FINAL MITIGATION PLAN

Catbird Site
Davie County, North Carolina

DMS Project #: 100022
Contract #: 7186
USACE Action ID: SAW-2017-01506
DWR Project #20171039
RFP: 16-006993

Re: NCIRT Review and USACE Approval of the Catbird Mitigation Plan; SAW-2017-01506; NCDMS Project # 100022

S3

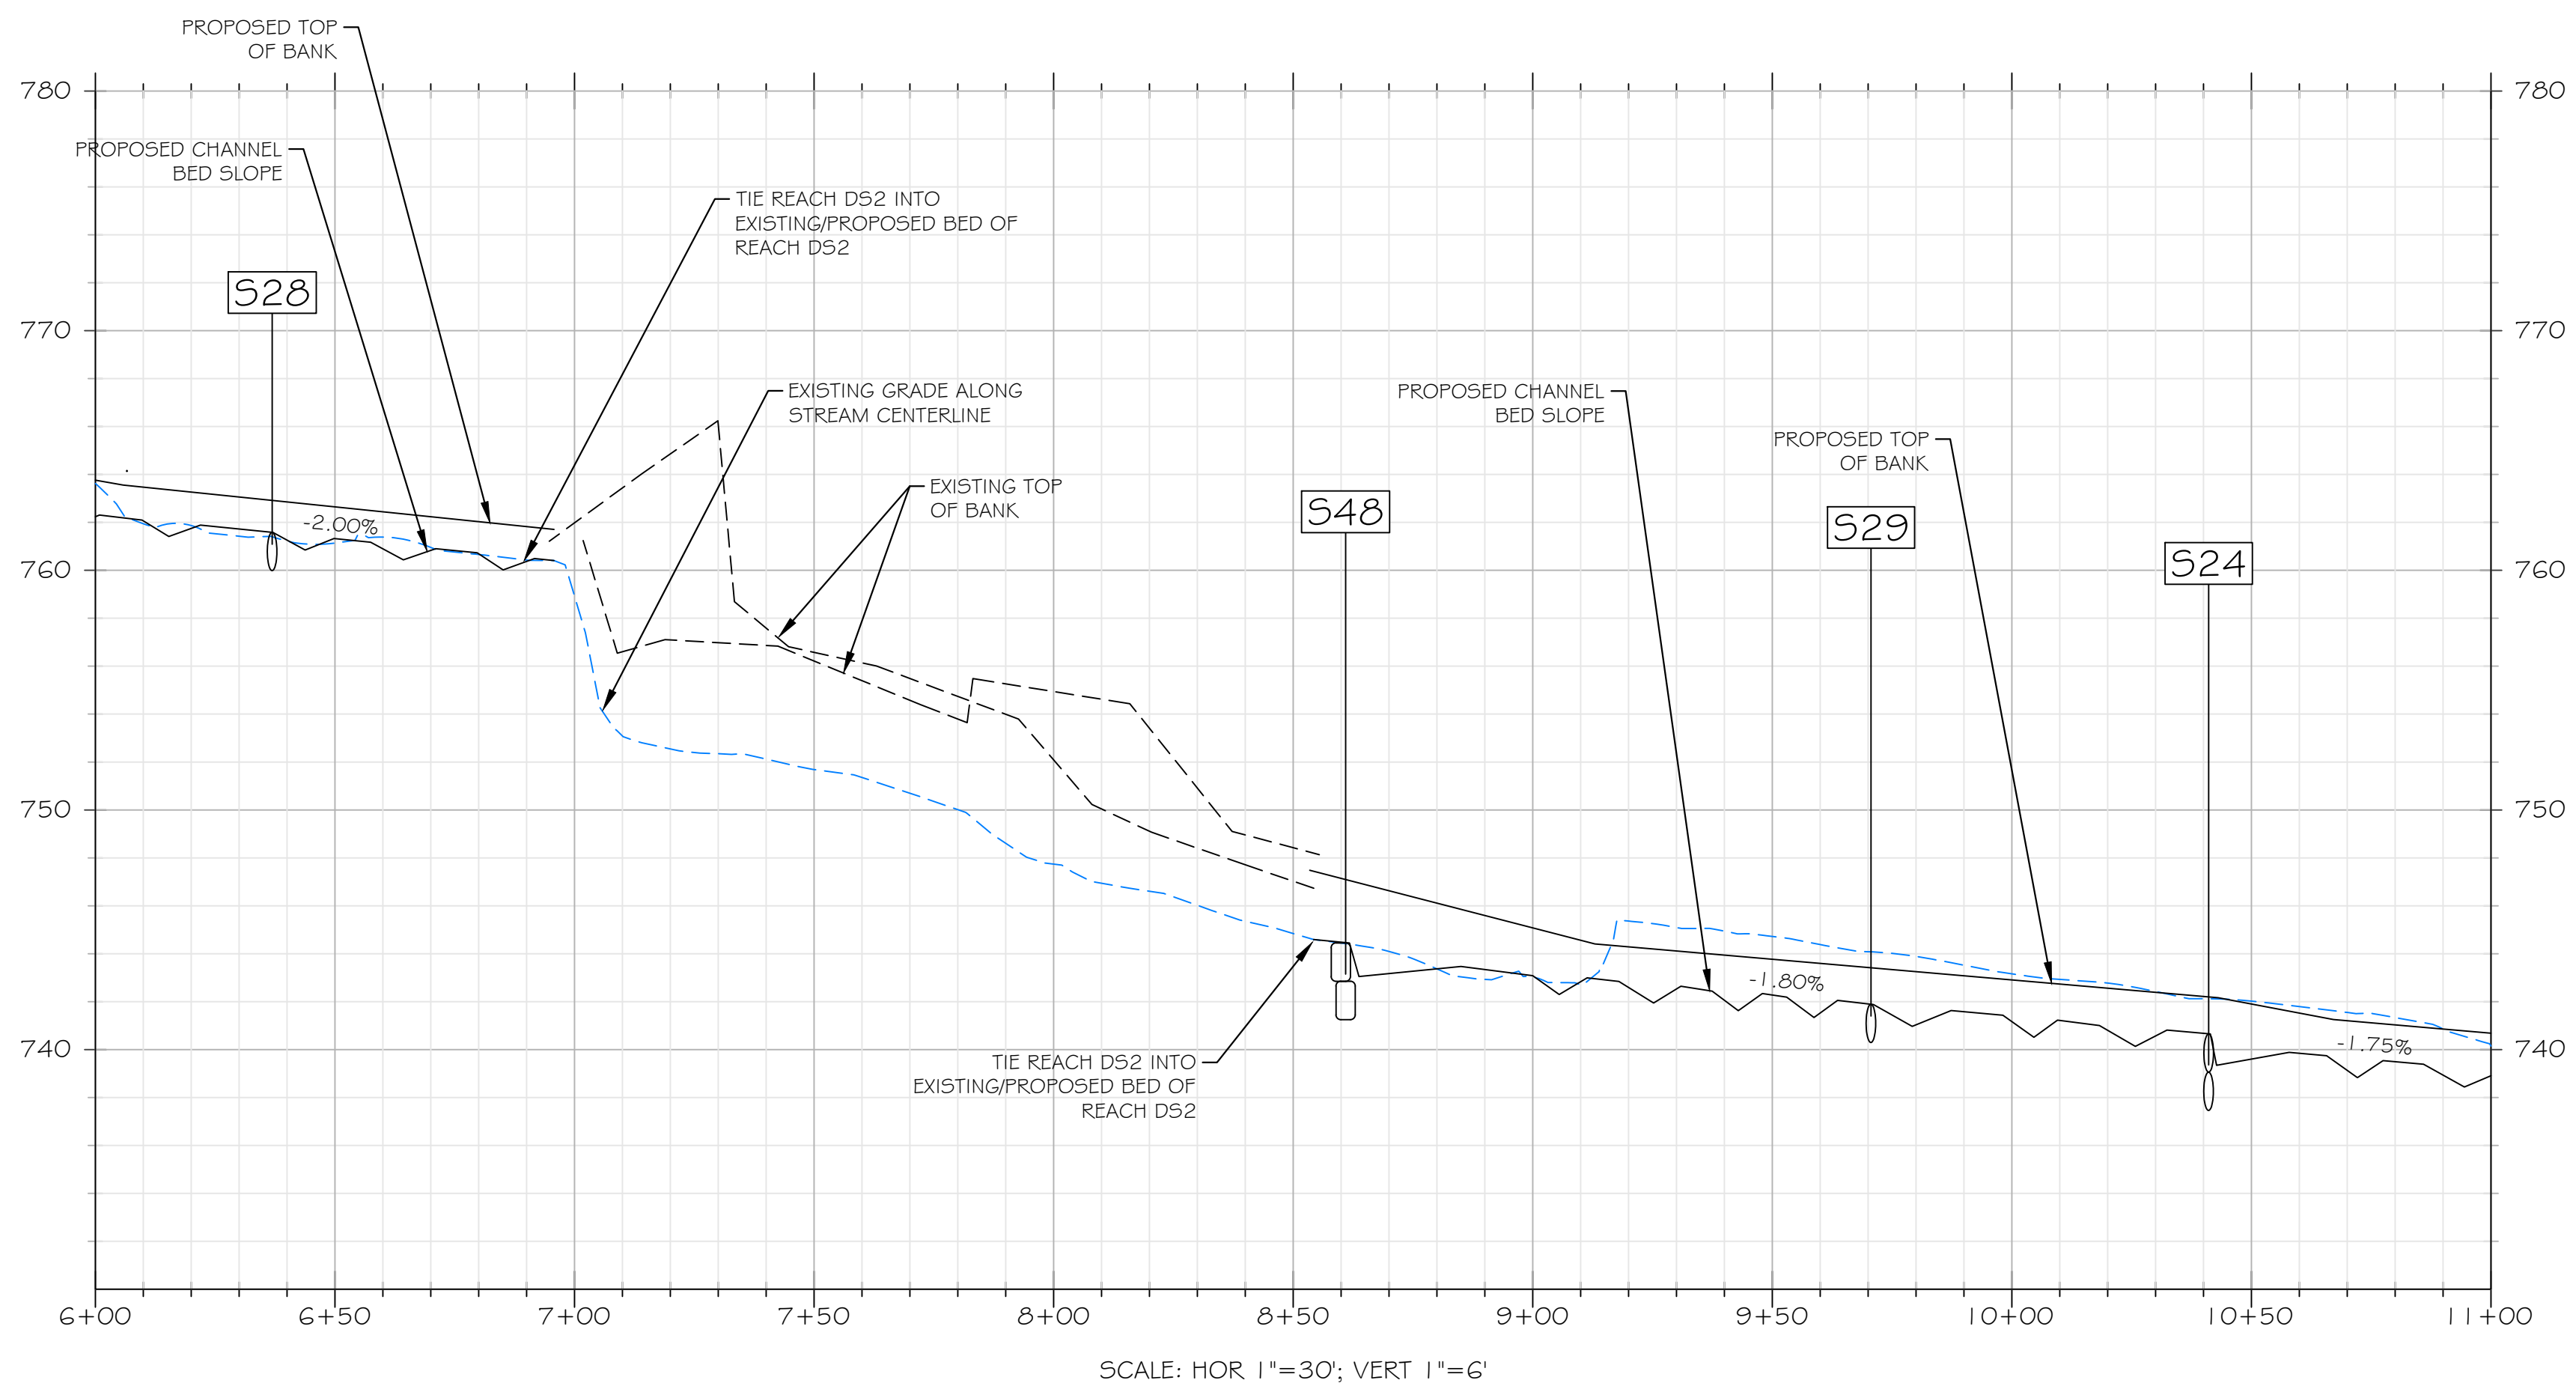
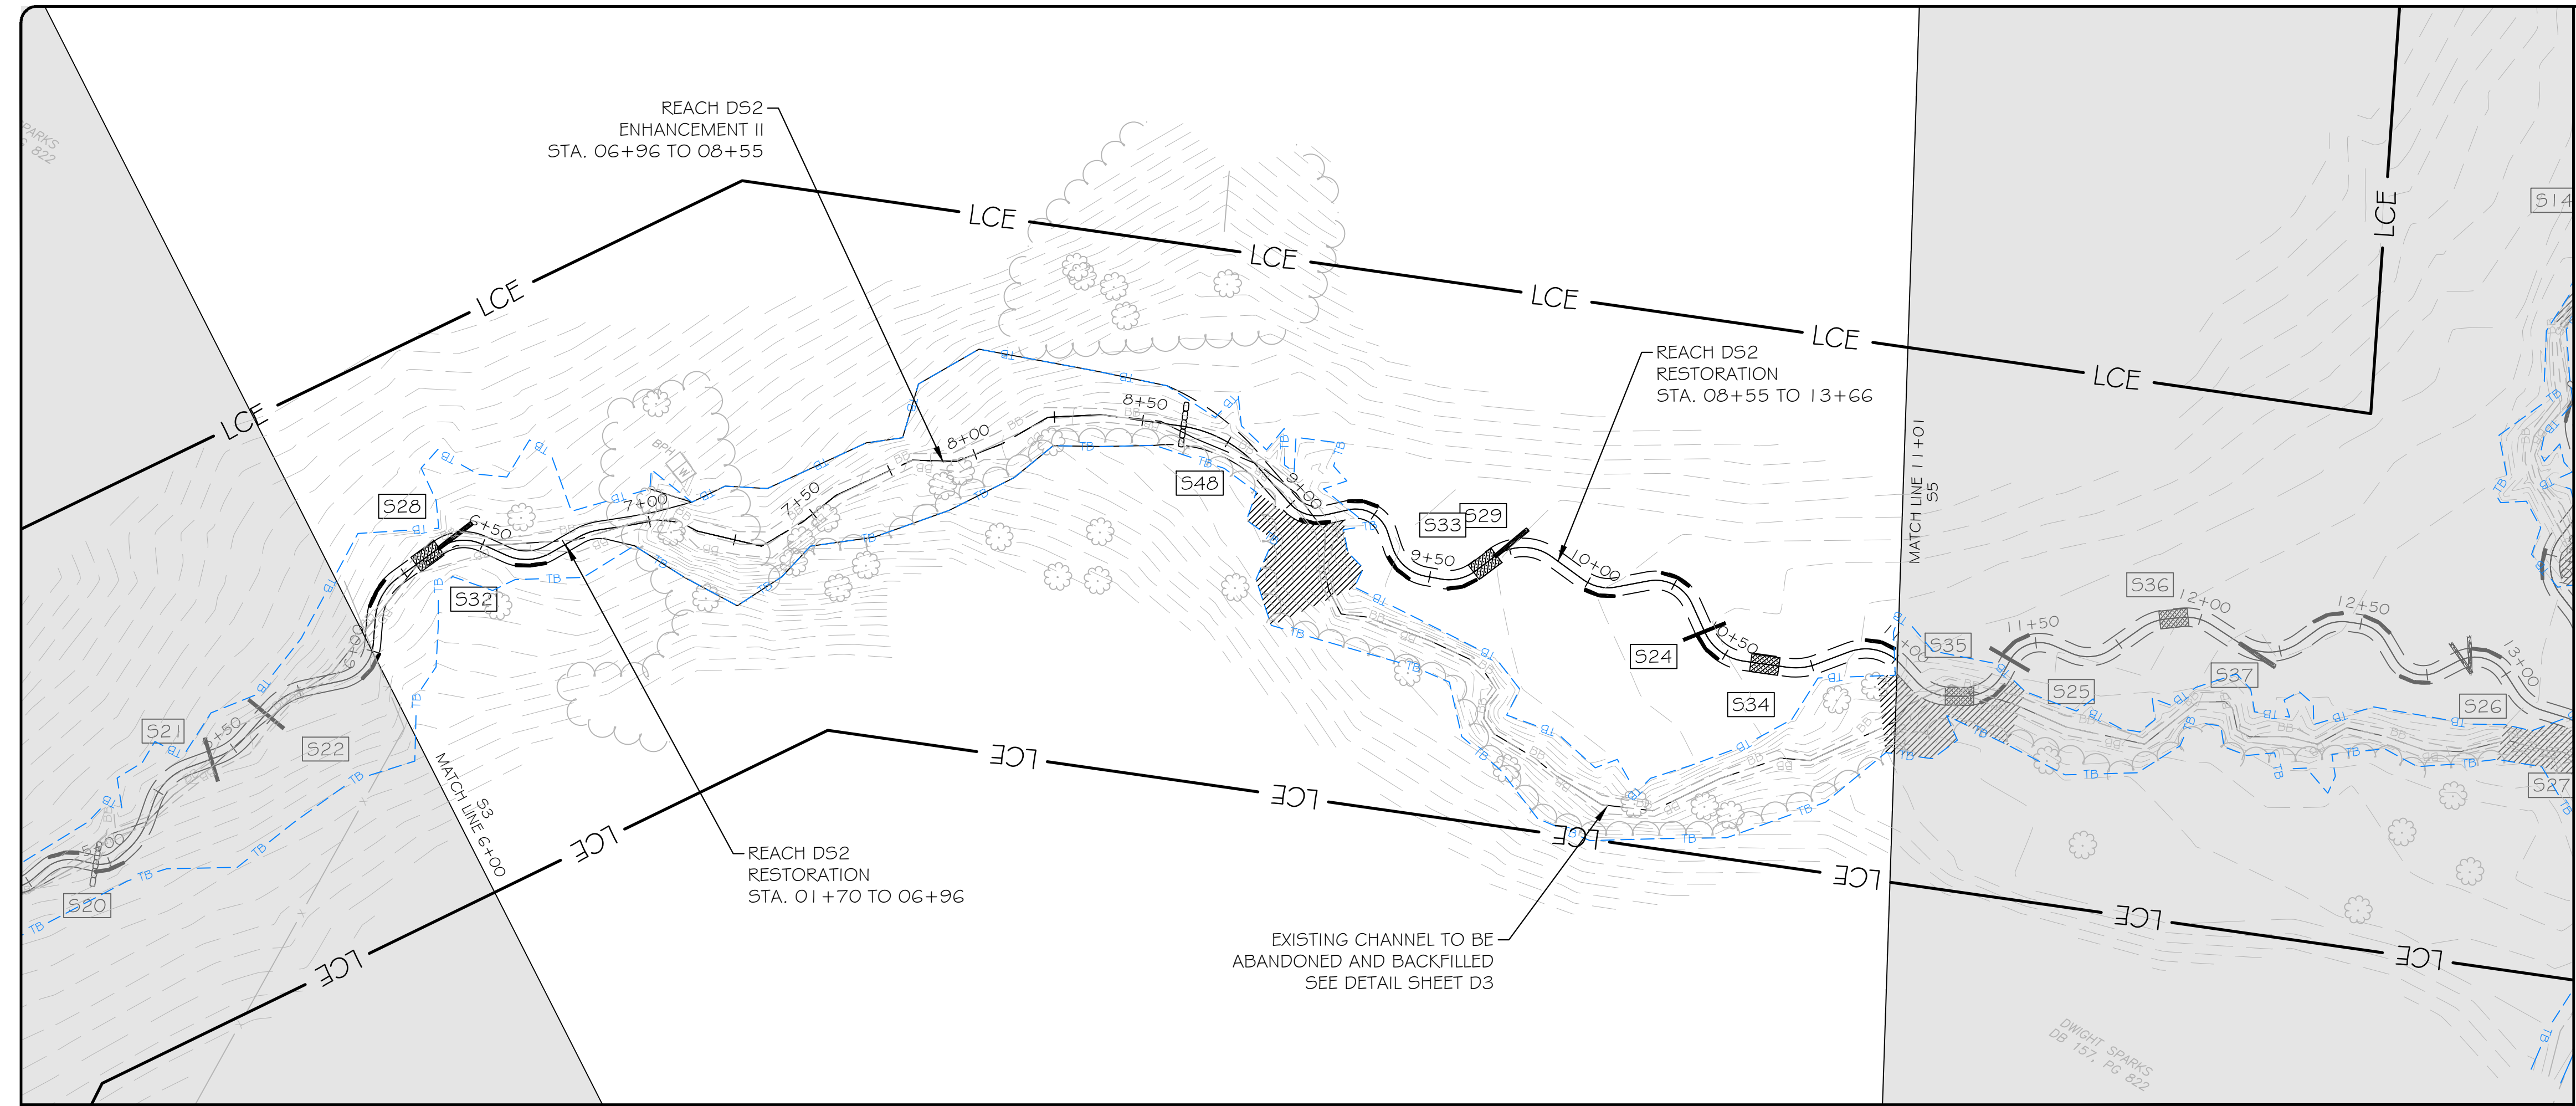
4. The design sheets need to show where the existing wetlands occur. Please provide a revised design sheet for this section (S3 ?), the whole set does not need to be revised.
[Sheet S3 has been revised to show existing wetlands, WA and WB.](#)

M1

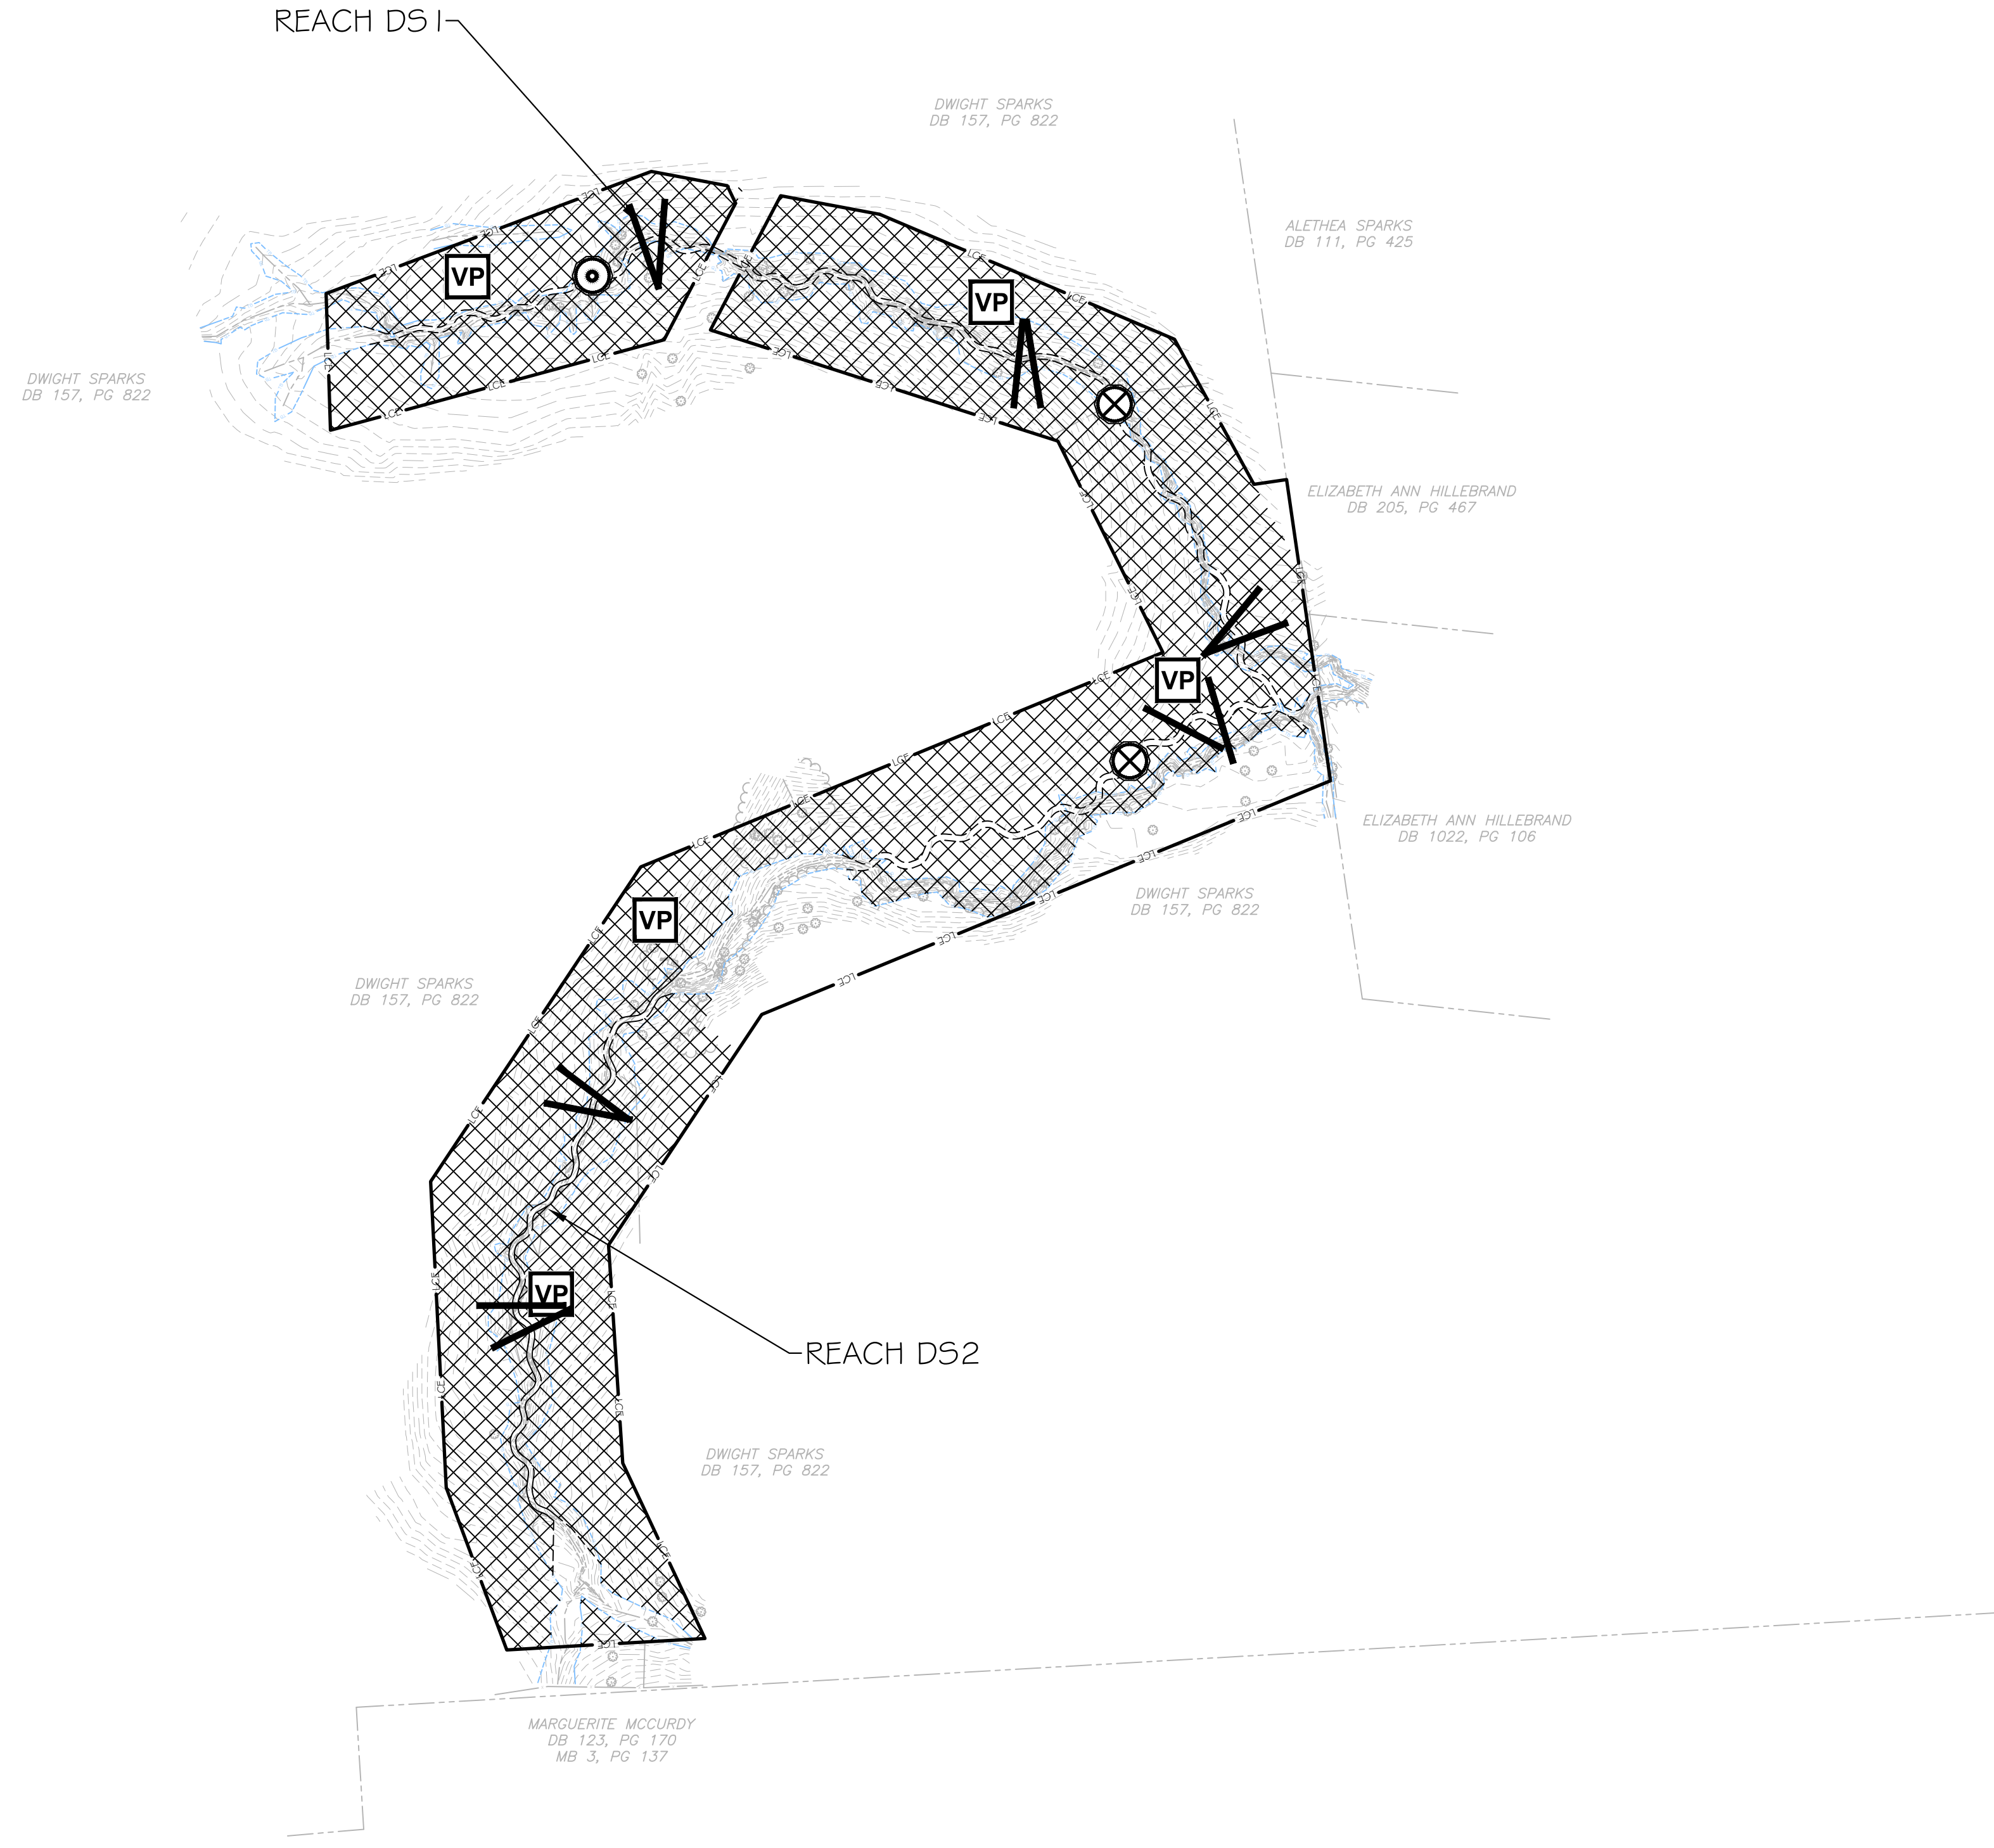
2. Please include a monitoring map which includes the location of veg plots, flow gauges, photo locations, and crest gauges, similar to sheet M1. [This has been included as Figure 11. Also, we realized there were far too many cross sections on the original monitoring sheet and both Sheet M1 and Figure 11 reflect these changes.](#)

- a) RES state that a flow monitoring device will be placed near the top of DS-1 to document post-construction flow conditions. However, Plan Sheet M1 indicates the planned flow gauge located towards the lower end of DS-1. Please clarify or correct this apparent discrepancy.

Sheet M1 shows a flow gauge at the top of DS1 and a crest gauge at the lower end of DS1.
